寄件日期: 2025年10月10日星期五 11:36
收件者: tpbpd/PLAND
副本: Yen PY LEUNG/PLAND; Ivan Sze Yuet FUNG/PLAND
主旨: 20251010 - S. 16 Planning Application No. A/YL-KTN/1160
附件: AYL-KTN 1160 20251010.pdf

有關對運輸署 A/YL-KTN/1160 的查詢

有關 A/YL-KTN/1160 的修改詳細

Proposed Temporary Place of Recreation, Sports or
Culture (Hobby Farm) with Ancillary Facilities and
Associated Filling of Land For a Period of 5 Years

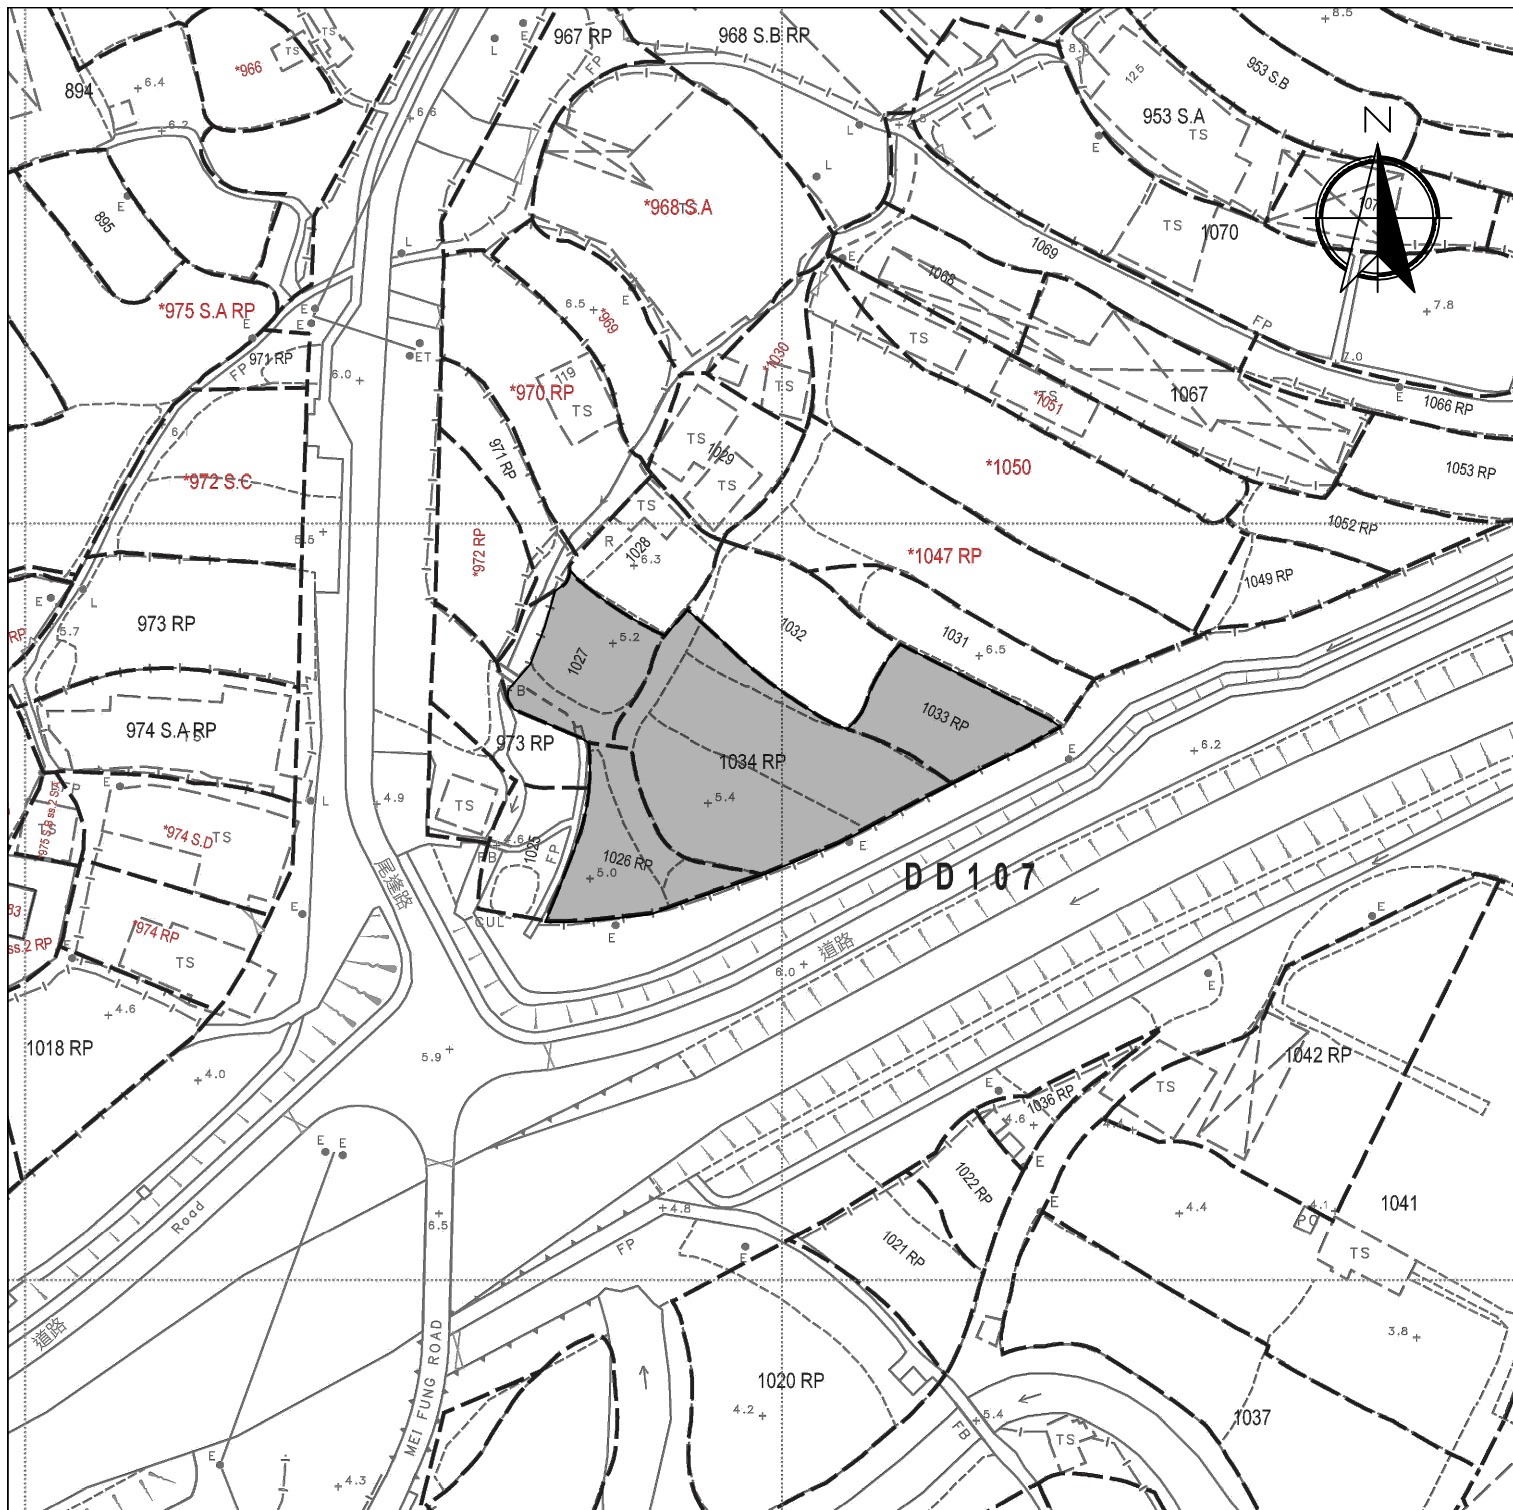
收悉 貴署對 A/YL-KTN/1160 申請的意見，本人現書面回覆。

前往至本申請地點主要使用尾邊路，該道路為一條單線雙程的道路，並備有避車處。經修改後，申請地點範圍內不會提供任何停車位及上落位置。使用人士需以公共交通工具前往。

在尾邊路的路邊可上落物料及參與人士，該位置只會用作上落用途，不會長期停泊。由於只有少量人數及物料，相信不會影響該路的運作。以下為上落位置：

申請地點可以公共交通工具到達，線路為綠色專線小巴 620 號線路前往至申請地點約 600 米外的小巴士站，再以步行形式約 8 分鐘前往申請地點，小巴士站請參考下圖：
